# 2004 - 2009 Cadillac XLR and XLR-V: Service Bulletin: XLR Roof Does Not Latch At Rear Corners In Stowed Position

## #PIC4547A: XLR Roof Does Not Latch At Rear Corners In Stowed Position - keywords latch loose mid open potentiometer retract stow trunk - (Oct 23, 2008)

**Subject:** XLR Roof Does Not Latch At Rear Corners In Stowed Position  
**Models:** 2004 - 2009 Cadillac XLR and V-Series

## (2) Loosen One Turn

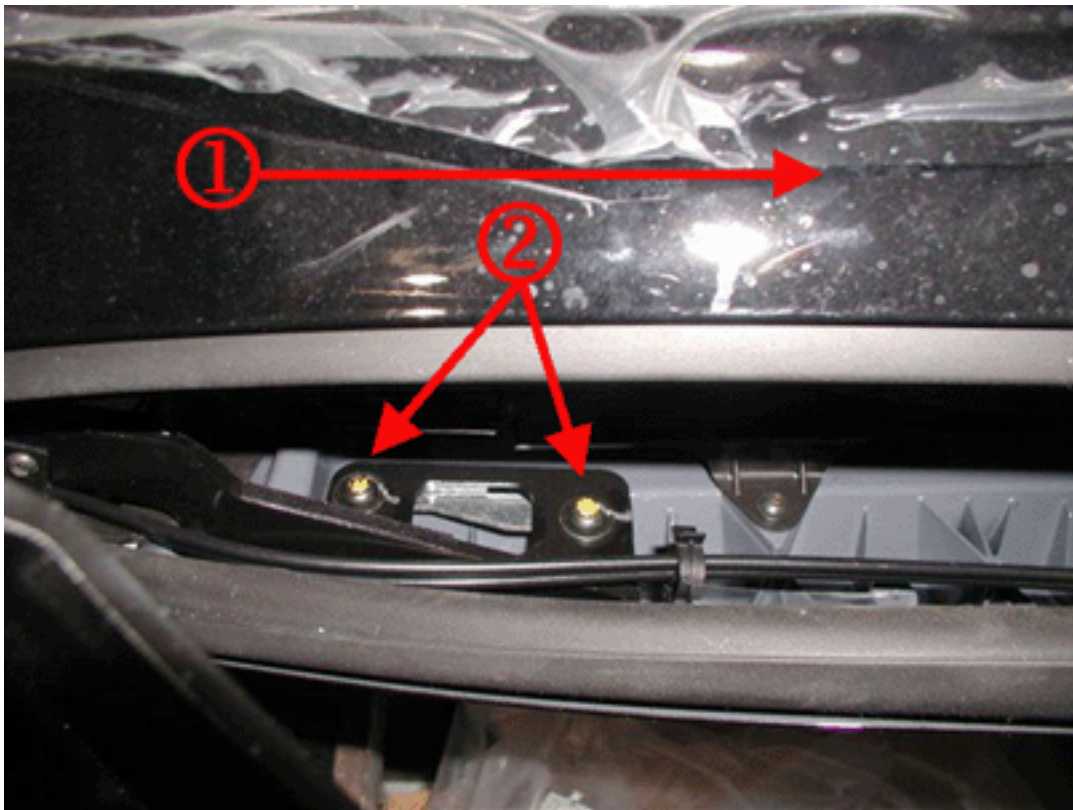
Some customers may comment of a mark in the paint on the roof panel. This mark may be on the drivers or passengers side of the roof and typically the size of a pencil eraser. Further inspection of the retractable roof may indicate when the roof is stowed, the rear corners of the roof are not secured in trunk area. This may be the result of a misadjusted roof panel.

1. Lower roof into trunk as far as it will go. Stop when trunk starts to close. Check to see if the rear roof latches engage the lower support.
2. Scribe the current position of the rear roof panel pivot bracket

bolts. These marks may be needed if the panel moves more than needed. The position should only change about .5 mm (one half mm).

3. Loosen both of the rear roof pivot brackets to rear roof panel fasteners one turn (both driver and passenger sides). These only need to be loose enough to allow the bracket to slide under the bolt shoulder. Do not allow the shims (if present) to become mis-positioned.
4. Manually lower the panel so the rear latches engage and latch. Lightly bump/thump the rear corners of the roof panel above the latches using your open palm.
5. Re-tighten the previously loosened fasteners to the specifications listed in S.I (Doc I.D. = 1739799)
6. Cycle the roof and ensure that it latches properly in both the up position and down position with out assistance. If it does not latch in the up position the strikers can be adjusted.
